**PUBLIC COMMENTS AND STAFF RESPONSES  
FOR**

**TOTAL MAXIMUM DAILY LOADS FOR NITROGEN COMPOUNDS AND  
ORTHOPHOSPHATE FOR THE LOWER SALINAS RIVER AND RECLAMATION  
CANAL BASIN AND THE MORO COJO SLOUGH SUBWATERSHED, MONTEREY  
COUNTY, CALIFORNIA (DRAFT PROJECT REPORT - OCTOBER 8, 2012)**

**Figure 1 Percentage of water quality samples (1999-2010) that are CURRENTLY meeting proposed biostimulatory targets for nitrate.**

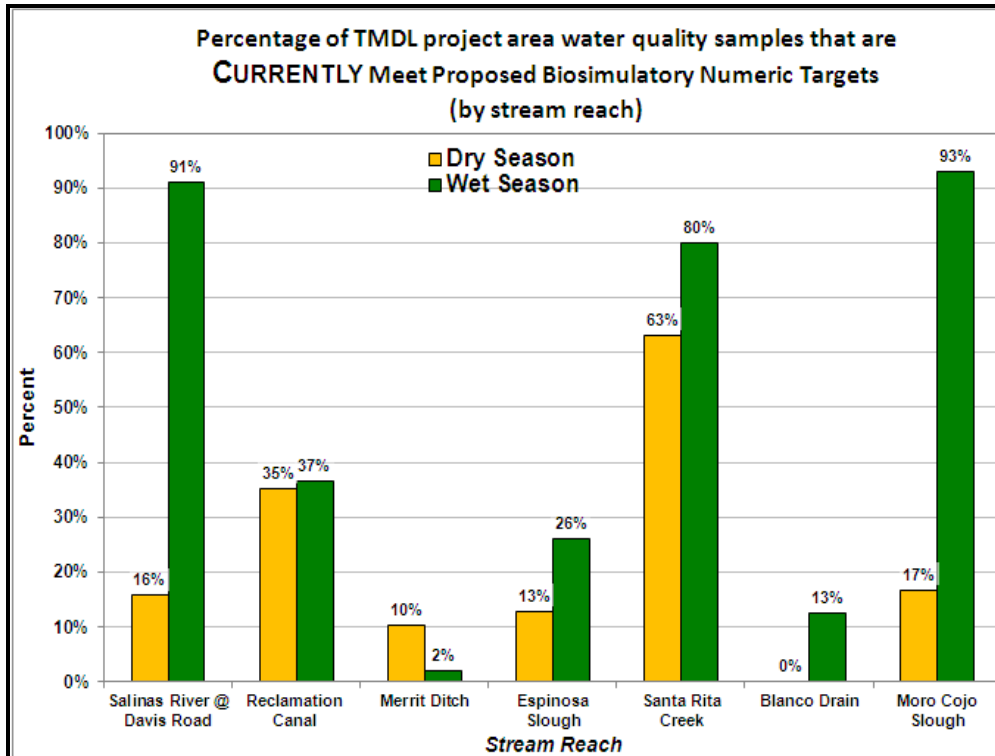
*Regarding the comments on the infeasibility of achieving the proposed water quality targets, it is important to note that the approaches staff used in biostimulatory water quality target development were based in part on USEPA-recognized statistical methods. Practically speaking, this means the approach staff employed was intended to facilitate numeric target development appropriate to local scales and local conditions. Since staff's approach included the 25<sup>th</sup> percentile approach applied at the project-area scale, as a practical matter this means that on average one out of every four (25%) water quality samples (monitoring years 1999-2010) on average are in fact already meeting the proposed biostimulatory targets. In other words, it is not accurate to suggest the targets are infeasible and cannot be achieved – they are already being achieved episodically in many stream reaches of the TMDL project area. It should be noted that achieving the targets in some stream reaches, like Blanco Drain, and Tembladero Slough, will indeed be challenging, either because upstream sources are contributing to the observed in-stream degradation (Tembladero Slough), or because control of shallow groundwater, tile drainage, and water management in a vegetable cropland setting present challenging technical issues locally. Figure 1 presents a graphical illustration of the frequency with which current and recent water quality samples already meet the proposed biostimulatory numeric water quality targets.*

Figure as provided by:  
Mr. Kirk F. Schmidt, Executive Director, Executive Director,  
Central Coast Water Quality Preservation, Inc.

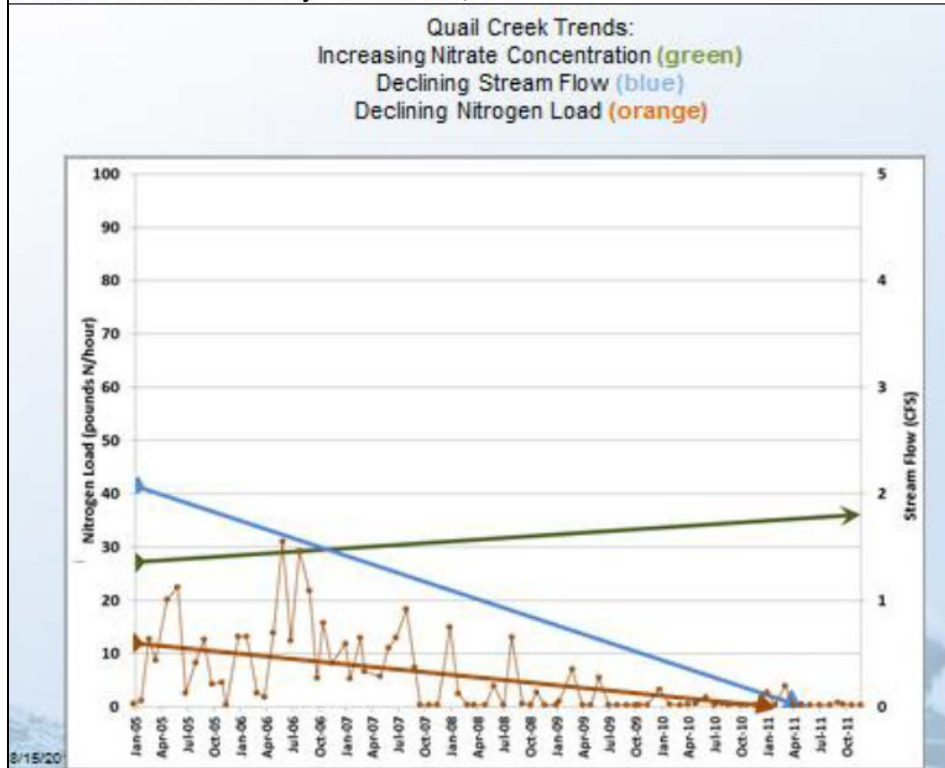
The failure to establish a load for any of the waterbodies in the TMDL boundaries means that there is no way to measure reduction of the amount of the impairment entering the receiving waters. A good example can be seen by the CMP monitoring over the last seven years at Quail Creek in Monterey County. The following chart shows a reduction in Nitrogen load between 2005 and 2011 greater than 95%, while N concentration increased slightly.

Due to the significant decline in stream flow, with only a nominal increase in N concentration, the load at the point of monitoring has declined. Regrettably concentration did not. This illustrates why concentration is not a good proxy for load. Furthermore, as flow declines and stream depth lessens there is the potential for a greater rate of evaporation, further increasing concentration with no change in overall load.

***Staff response: Thank you for the comment and staff appreciates the opportunity to provide clarification here. Staff concurs that mass load-based expressions can provide a meaningful connection with implementation efforts. These alternative mass-based load expressions are incorporated in the final draft TMDL project report and the proposed Basin Plan amendment as will be discussed and addressed below.***

Figure 2. STORET legacy data - water quality sampling frequency distribution.

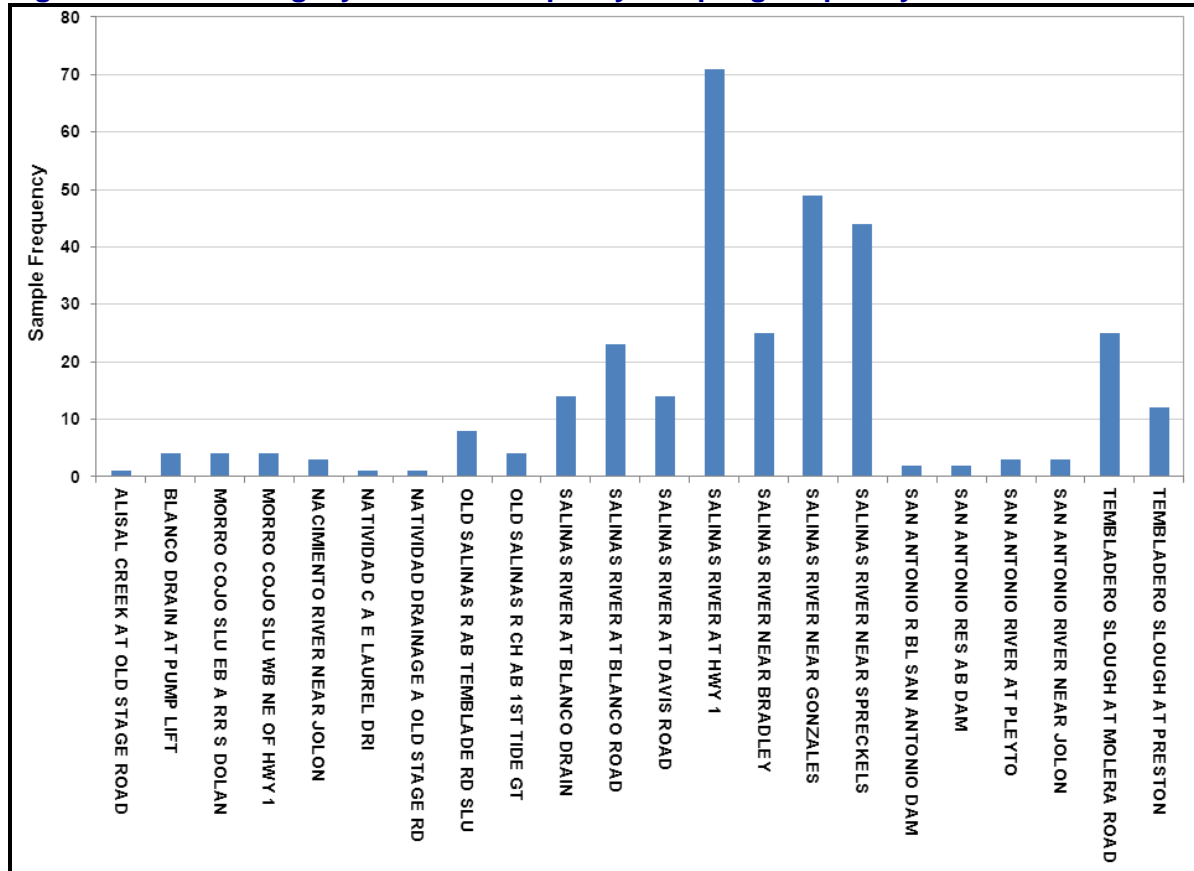
*Monitoring sites from the beginning of the period of record have been routinely and consistently sampled throughout the period of record. The 1960s, 1970s, and 1980s-vintage STORET legacy data<sup>18</sup> is overwhelmingly from the Old Salinas River, Tembladero Slough, and the lower Salinas River downstream of Spreckels (see Figure 2). Indeed, these particular sites have been routinely sampled temporally throughout the period of record including and up to the most recent monitoring data. This provides a certain level of spatial consistency through time. STORET legacy data also has a nominal amount of data from the middle and upper Salinas River basin. Also, the STORET legacy monitoring sites overwhelmingly correspond to sites currently sampled by the CCAMP and CMP monitoring programs. As implied by Ms. Lopez however, over time, additional monitoring sites have been added in the Salinas Valley, through the CCAMP and CMP monitoring programs.*

Since the older vintage STORET data is largely from the lowermost Salinas Valley, staff do not concur with the comment that early data do not include groundwater-influenced monitoring sites. Indeed, as noted previously, most of the STORET legacy data are from the Old Salinas River, Tembladero Slough, the Salinas River downstream of Spreckels, and the Salinas River above the lagoon - these are lower alluvial basin floor and coastal confluence areas receiving substantial groundwater, tile drainage, and agricultural return flows. In other words, the older-vintage STORET legacy data is in fact heavily biased towards lower alluvial basin floor and coastal confluence areas that have historically been impacted by nutrients and agricultural drainage for many decades, and would be expected to have higher nutrient concentrations relative to upland ecosystems and upper watershed reaches.

**Figure 4. Losing stream and gaining stream.**

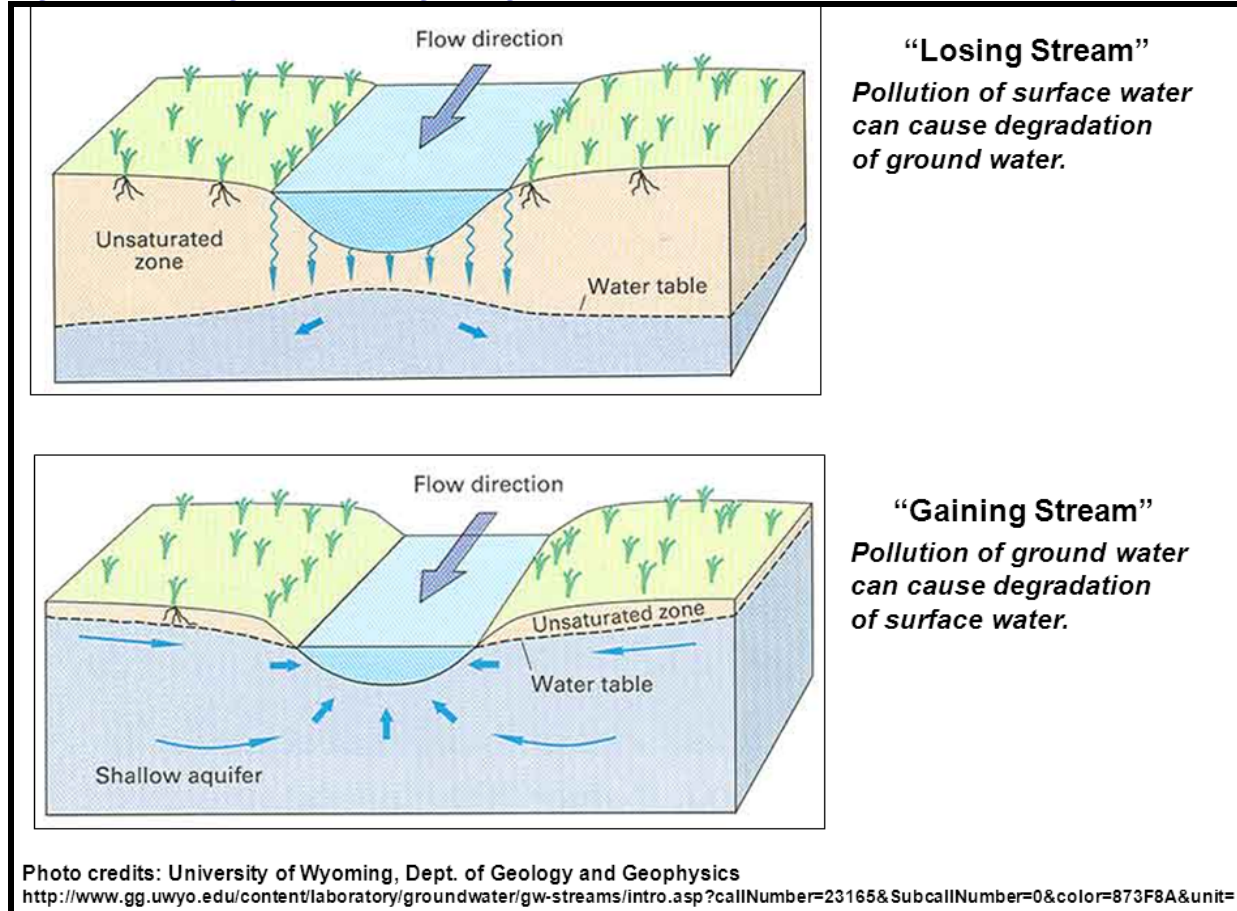
The comparison between agriculture, urban, and undeveloped land has been absent from previous analyses. It would have been helpful if ranges of measured nitrate concentrations were provided to compare to modeled nitrate concentrations. Is it assumed that predicted and estimated nitrate concentrations are the same factor? Also, please note that these figures as well as Figure 2-17 do not include a date or timeframe.

***It should noted that some insights on groundwater interactions with streams can be deduced from field observation, and local knowledge of land and stream flow conditions. Gaining streams (those receiving groundwater inputs) would generally be expected to be located in lower reaches of alluvial basin floor areas where perennial flows are observed and local soil conditions and perched or shallow groundwater horizons are known or expected to exist. Headwater and upland reaches are sometimes expected to have gaining stream hydraulics as well. Losing streams (those which percolate to groundwater and do not receive substantial groundwater inputs, particularly in the dry season) would be expected to be associated with intermittent streams located on alluvial fan and alluvial plain geomorphic settings of the project area where high permeability soil and stream substrate conditions exist. These reaches would exhibit intermittent flows or dry stream beds in the absence of artificial return flows. Conceptually, the aforementioned information is illustrated in Figure 4.***

Figure 6. MCWRA nitrate water quality data in the 400 foot aquifer (median for 400 foot aquifer = 3 mg/L nitrate as NO<sub>3</sub>).

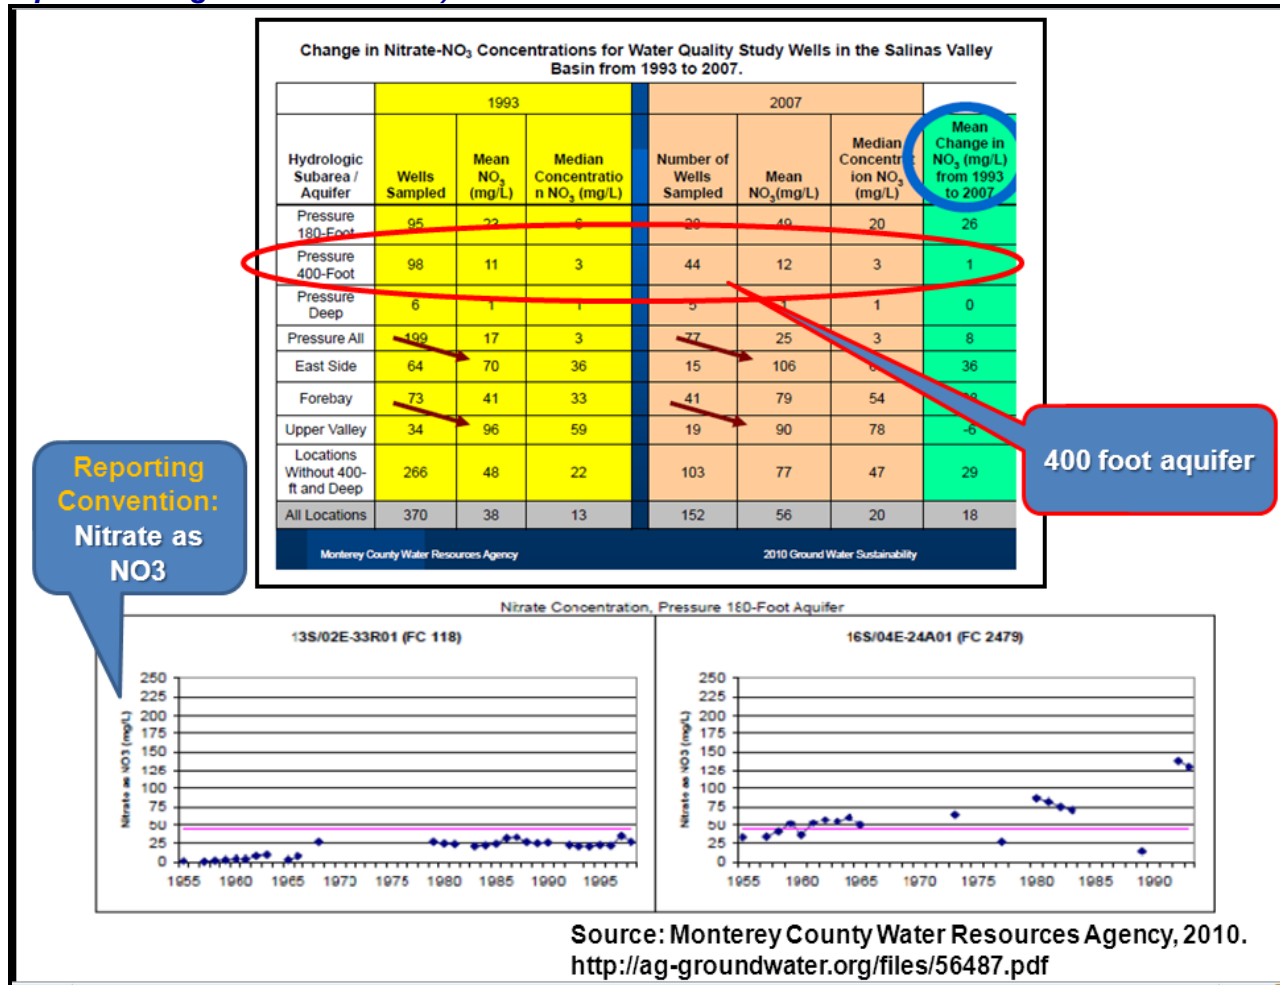
Ms. Taylor-Siva and Ms. Mercer cite reporting from MCWRA and suggest that background concentrations of nitrate in groundwater are around 3 mg/L, based on observed nitrate concentrations in the 400 foot aquifer. Staff agrees with this comment, and that 3 mg/L nitrate-NO<sub>3</sub> could indeed be considered a plausible background concentration in the 400 foot aquifer. However, it is important to reiterate and recognize that the 3 mg/L value reported by MCWRA is on the basis of the nitrate as NO<sub>3</sub> convention (see Figure 6).

Note that this MCWRA reported 3 mg/L nitrate-NO<sub>3</sub> value is equivalent to 0.7 mg/L nitrate when it is reported in the nitrate-nitrogen convention<sup>23</sup>. As noted previously, staff's estimate of shallow groundwater nitrate concentration is 1.21 mg/L nitrate as nitrogen – consequently, note that staff's estimate is actually substantially higher than the 0.7 mg/L nitrate as nitrogen reporting from MCWRA. This information is also graphically illustrated in Figure 7

*Figure 13. Computer screen-capture from October 2012 draft TMDL Project Report–Appendix D: An example of monitoring sites, stream and landscape criteria, and water quality statistics used in derivation of proposed nutrient targets in the alluvial valley basin floor stream category.*

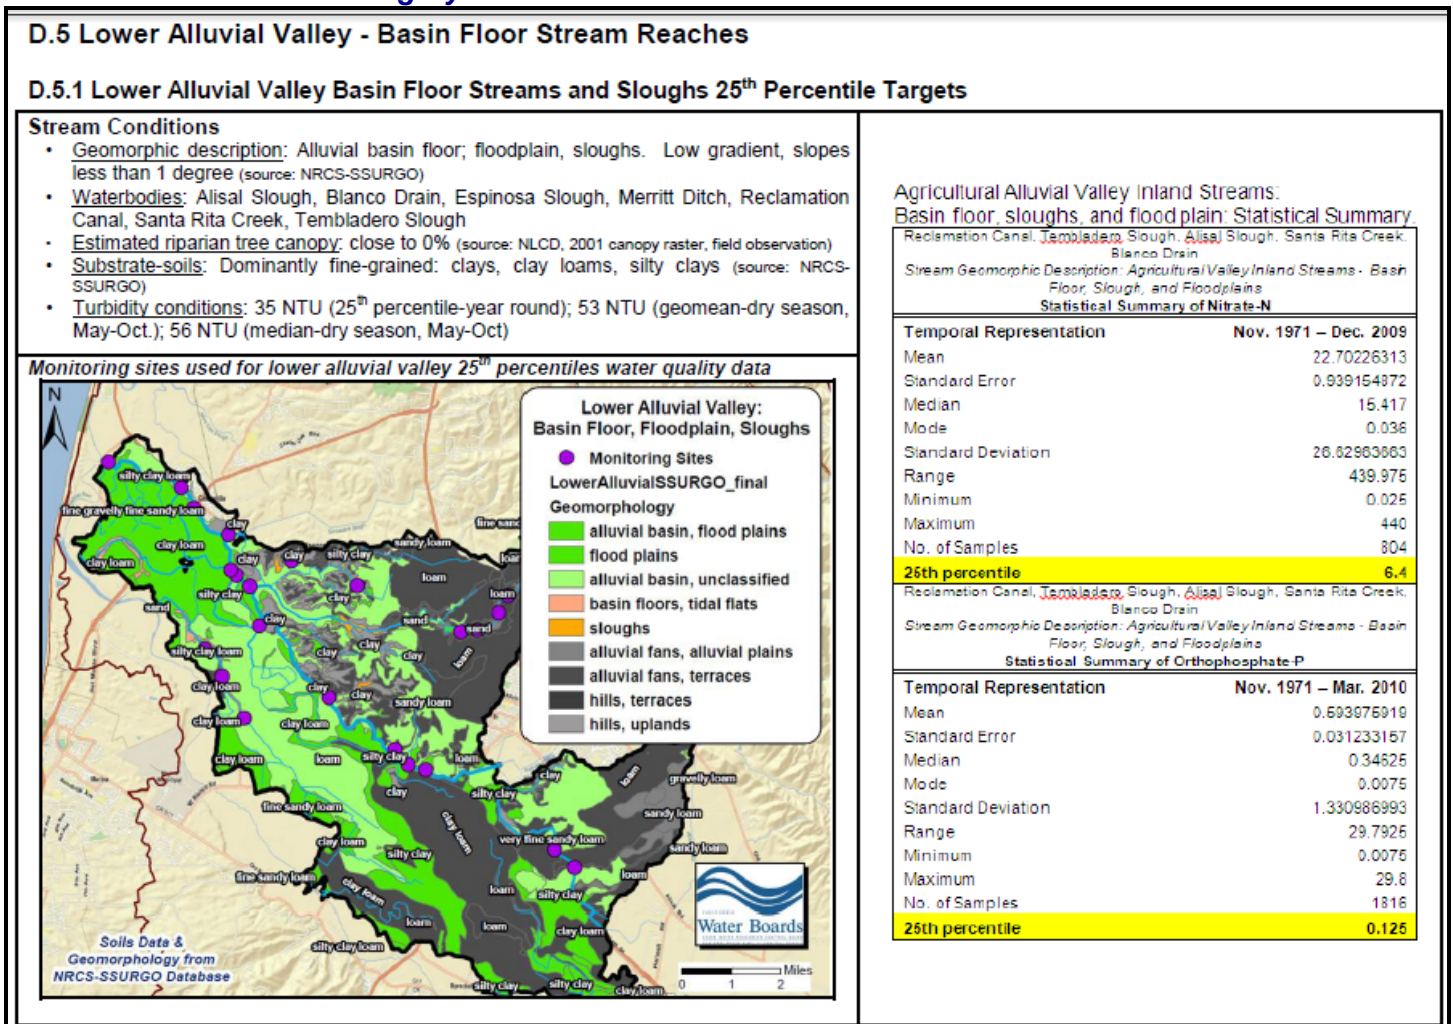
One concern that arises is the appropriateness of using the SWRCB draft Statewide Nutrient Policy recommendations to craft numeric targets in this TMDL. Until this policy is adopted, it is not the controlling guidance, and we recommend that Staff constrain the TMDL to currently adopted policies, procedures, and regulations. Another concern that exists is the use of surrogates for reference stream populations when those surrogates are derived from nutrient ecoregions significantly different from the Salinas Valley. The use of data from Minnesota lakes and Tennessee streams are not appropriate surrogates. We suggest the development of alternative surrogates using locally pertinent data or the abandonment of the use of the 25th percentile surrogates as proposed by the EPA.

*Regarding the comment on use of data, staff did not use data from Minnesota Lakes and Tennessee streams. Reference to Minnesota and Tennessee in the October 2012 draft project report was historical references and backdrop pertaining to USEPA's nutrient criteria guidance document. As documented in the October 2012 draft Project Report Appendix D – Nutrient Target development, Staff only used local and TMDL project-area specific data in the derivation of proposed nutrient water quality targets. For ease of reference, a screen capture from Project Report–Appendix D is shown in Figure 13 and provides an example of the monitoring sites, stream and landscape criteria, and water quality statistics for the alluvial valley basin floor stream category staff developed to support nutrient target development.*
